DELETED**First Revision No. 43-NFPA 24-2019 [Global Input]**

First Revision No. 2-NFPA 24-2019 [Section No. 1.1]

Figure A.7.3.1 Typical Dry Barrel Hydrant Connection.

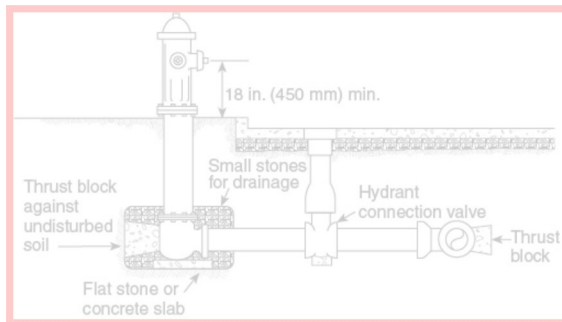
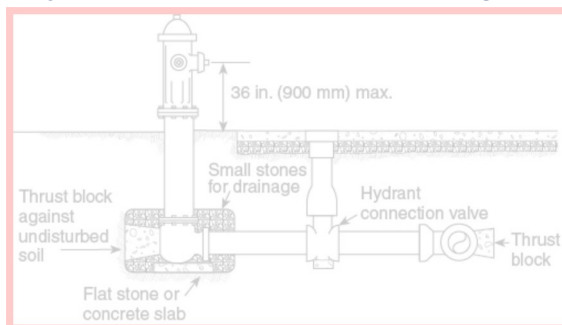
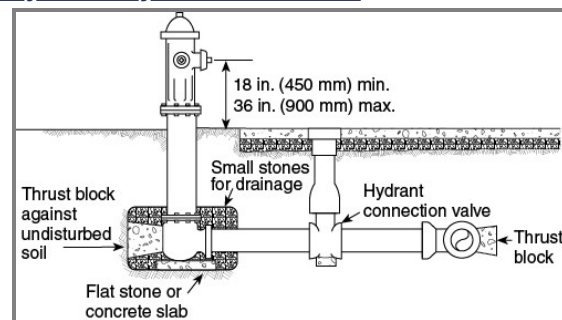
This proposal is also to eliminate redundancy. The only difference between the current Figures A.7.3.1(a) and A.7.3.1(b) is the maximum and minimum heights of the hydrant outlets. Those values can be shown on just one illustration.

Small stones or an approved equivalent shall be provided about below and around the drain in an adequate amount to prevent the weep hole from being clogged with native soil, mud, or debris that would prevent adequate drainage for dry barrel hydrants .

Figure A.10.4.3.1 Riser Entrance Location and Clearance.

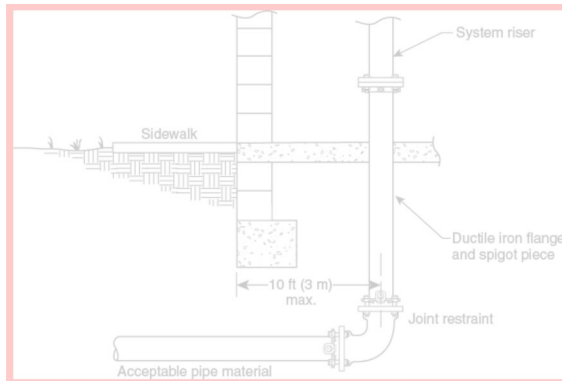
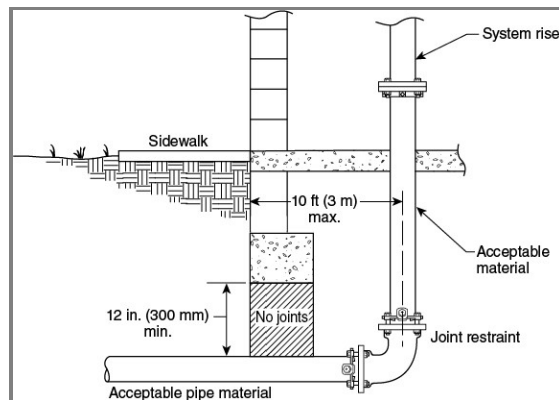
Committee Statement: This proposal is to eliminate the word "allowed", which is used twice in the current 10.4.3 and to eliminate redundancy. and to provide an illustration of a main being run in a covered trench below the floor.

Items such as sidewalks or patios should not be included as they are no different from roadways. See Figure A.10.4.3.1. The intent of this section is to limit the total length of horizontal pipe beneath the building to not more than 10 ft (3 m). See Figure A.10.4.3.1.

Figure A.10.4.3.1.1 Pipe Joint Location in Relation to Foundation Footings.

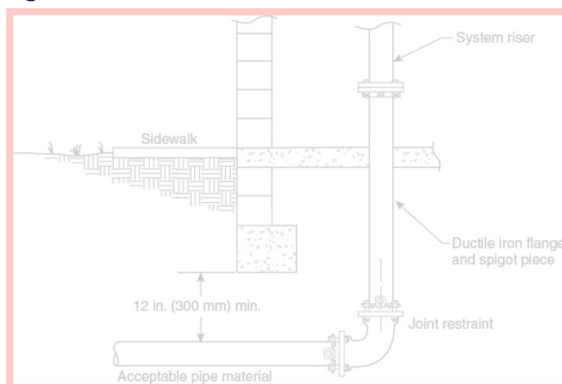
These actions call for the asterix (*) for Sections 10.4.3.1.1 and 10.4.3.1.2 to be deleted and for a new asterix (*) to be added to Section 10.4.3.2.1.

Pipe joints shall not be located directly under foundation footings.

Figure A.10.4.2 Recommended Depth of Cover (in feet) Above Top of Underground Yard Mains.

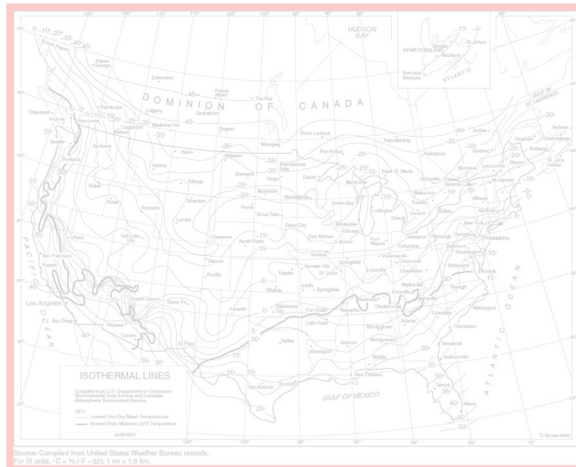
As there is normally no circulation of water in private fire mains, they require greater depth of covering than do public mains. Greater depth is required in a loose gravelly soil (or in rock) than in compact soil containing large quantities of clay. The recommended depth of cover above the top of underground yard mains is shown in Figure A.10.4.2(a) Figure A.10.4.2 .

In determining the need to protect aboveground piping from freezing, the lowest mean temperature should be considered as shown in Figure A.10.4.2(b) .
